Clarksburg Road – Frederick Road (CIP Project No. 508000-09), Mandatory Referral No. MR2018019

Mandatory Referral MR2018019: Clarksburg Road – Frederick Road

TO: Laura Hodgson, Planner Coordinator, Area 3, Planning Department
VIA: Mitra Pedoeem, Deputy Director *Mitra*
 Jai Cole, Acting Chief, Park Planning and Stewardship Division (PPSD) *Jai*
FROM: Brenda Sandberg, Legacy Open Space Program Manager, PPSD *BS*
SUBJECT: **Mandatory Referral MR2018019 – Clarksburg Road at Frederick Road (MD355)**

Figure 4: Clarksburg Road Typical Cross Section

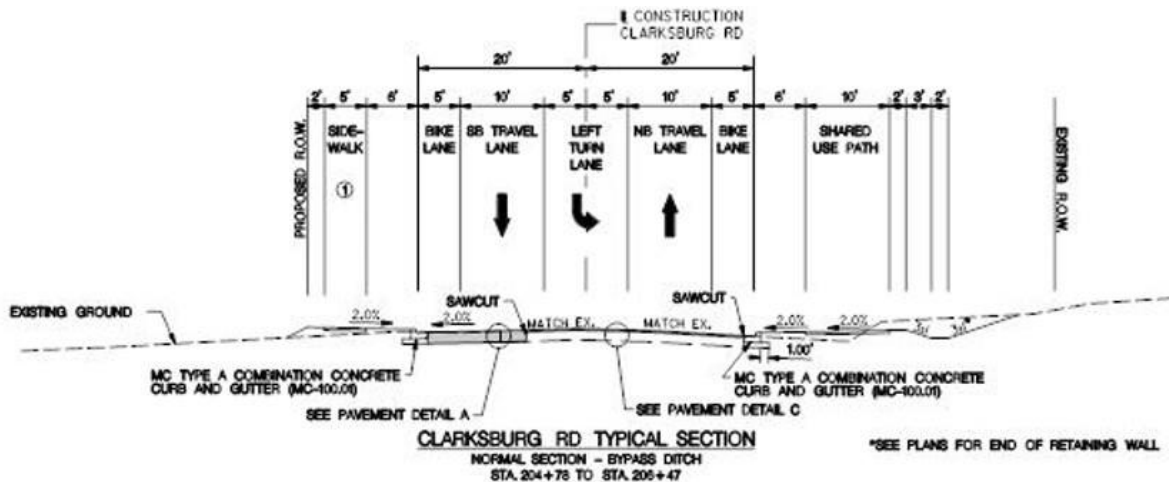
Bike lanes are added to Clarksburg Road east of Frederick Road and are slightly narrower than the 5.5-foot wide bike lanes prescribed in MCDOT Design Standards to be consistent with the bike lanes in the CIP project to the east (Clarksburg Road at Snowden Farm Parkway, CIP 508000-03). The proposed sidepath width on the southeast side of Clarksburg Road is 10-foot wide, which exceeds the minimum sidepath width requirement of 8 feet in an environmentally sensitive area per the County Council’s Expedited Bill 33-13 (Urban Road Code standards). This sidepath is two feet wider than the sidepath of the CIP project to the east (CIP 508000-03). The proposed sidewalk width on the northeast side is 5 feet. Adequate 6-foot wide buffers are proposed between the curb and bicycle/pedestrian facilities.

According to the County Council's Expedited Bill No. 33-13, the maximum target speed for a county-owned road in an urban area is 25 mph. For the subject project, only Clarksburg Road to the east of Frederick Road is a county road, the remainder of the roads are under the jurisdiction of Maryland State Highway Administration. Clarksburg Road east of the intersection has been designed with a 35 mph design speed with the assumption that the proposed posted speed limit after construction will be 35 mph. Therefore, road speeds on this road will not be consistent with the Urban Road Code designation of 25 mph.

Figure 8: Provide Pedestrian Ramps at Mid-block Crossings

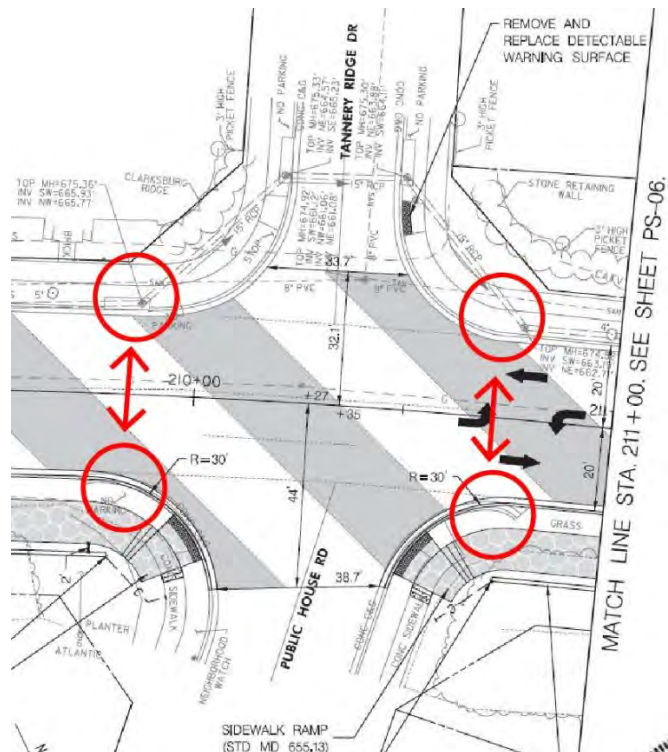
Additionally, pedestrian ramps/sidewalk lead-ins should be added at the intersections of Clarksburg Road and Tannery Ridge Drive/Public House Road and Clarksburg Road and Catawba Manor Way/General Store Drive to not preclude pedestrians from crossing Clarksburg Road at these locations (see Figure 8).
